**ZONING AMENDMENT &  
SUBDIVISION STAFF REPORT****Date: June 17, 2004****NAME**

Everglaze Subdivision

**LOCATION**5358 Moffett Road  
(North side of Moffett Road, 225'± East of Colonial Circle  
South)**CITY COUNCIL  
DISTRICT**

## SITE PLAN

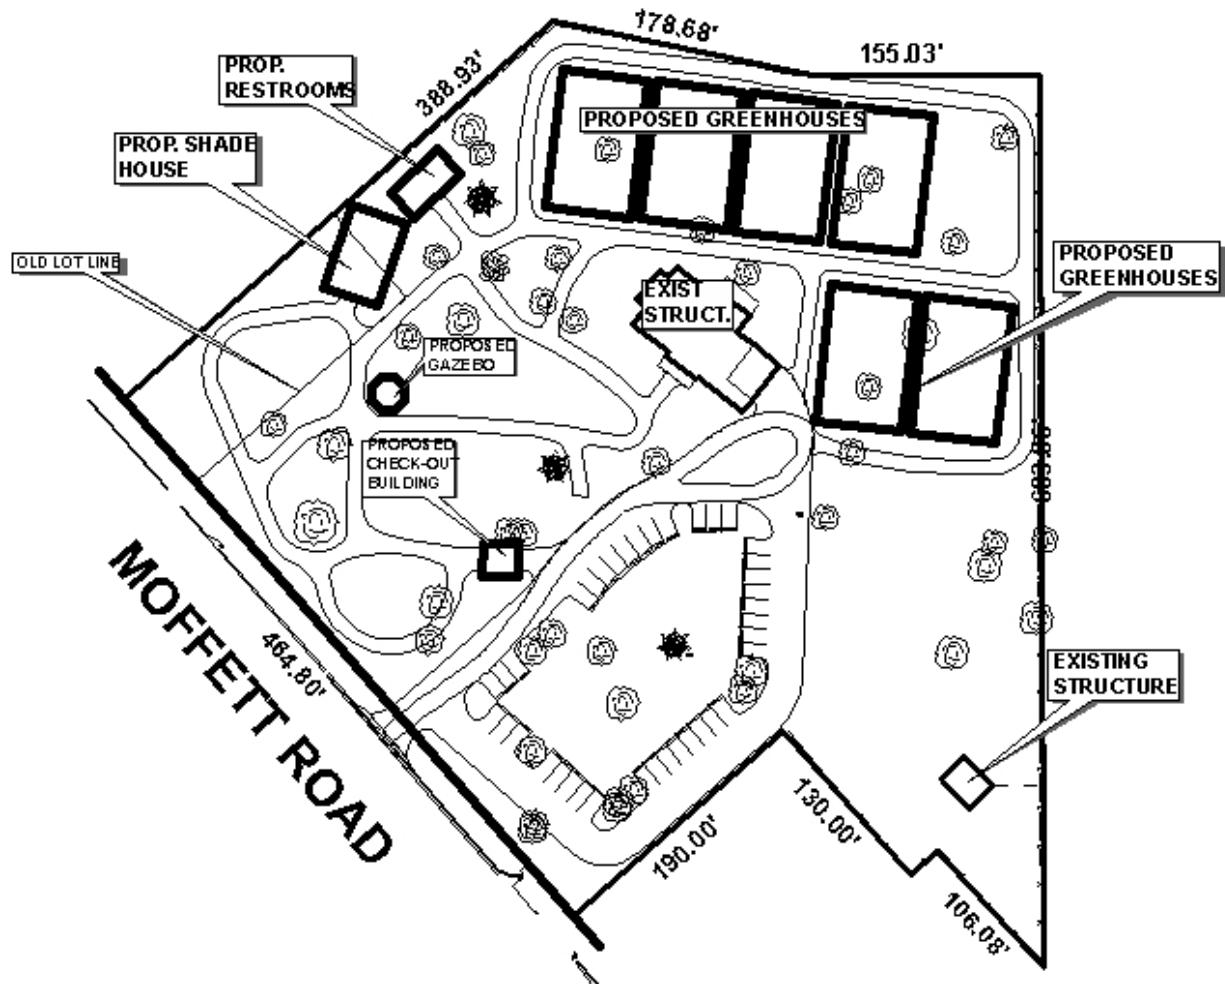
Additionally, the proposed site plan contains multiple buildings, thus PUD approval would be required. It should also be noted that the proposed shade house does not provide an adequate setback from the adjacent residential property line. Likewise, the walking path around the greenhouses abuts the residential property line to the rear which could infringe upon the privacy of the adjoining residential properties. Furthermore, gravel parking is proposed, but is prohibited in B-3 districts.

*The applicant has submitted a Planned Unit Development application; however, many of the site plan concerns remain; all buildings and walkways should be setback at least 10-feet from residential property lines and all parking must be paved.*

*It should be noted that the site plan does not illustrate a buffer adjoining residentially property; and a buffer in compliance with Section IV.D.1, is required where the site adjoins residential zoning. Furthermore, the provision of a sidewalk along Moffett Road, and the approval of the location and design of the curb cut by Traffic Engineering and Alabama Department of Transportation (ALDOT) will also be required.*

**Rezoning:** *Based upon the preceding, this application is recommended for approval subject to the following conditions: 1) Voluntary Conditions and Use Restrictions as submitted by the applicant; 2) that all buildings and walkways be setback at least 10-feet from residential property; 3) the provision of paved parking; 4) the provision of a buffer, in compliance with Section IV.D.1. of the Zoning Ordinance, where the site adjoins residential property; 5) the provision of a sidewalk along Moffett Road; 6) the approval of the curb cut by both Traffic Engineering and the Alabama Department of Transportation; 7) full compliance with the Urban Forestry Comments (property to be developed in compliance with state and local laws that pertain to tree preservation and protection on both city and private properties [State Act 61-929 and City Code Chapters 57 and 64]; that the 42" Live Oak in the South corner of the property, the 40" Live Oak in the South green space, the 72" Live Oak in the Southwest corner, the cluster of two Live Oak Trees, 35" and 48" to the West side of the property in the green space, the 36" Live Oak on the East side of the property be given preservation status [any work on or under these trees is to be permitted and coordinated with Urban Forestry; removal to be permitted only in the case of disease or impending danger. As a*

***Subdivision:*** *The plat meets the minimum requirements of the Subdivision Regulations and is recommended for Tentative Approval subject to the following conditions: 1) the provision of a sidewalk along Moffett Road; and 2) the approval of the curb cut by both Traffic Engineering and the Alabama Department of Transportation;*
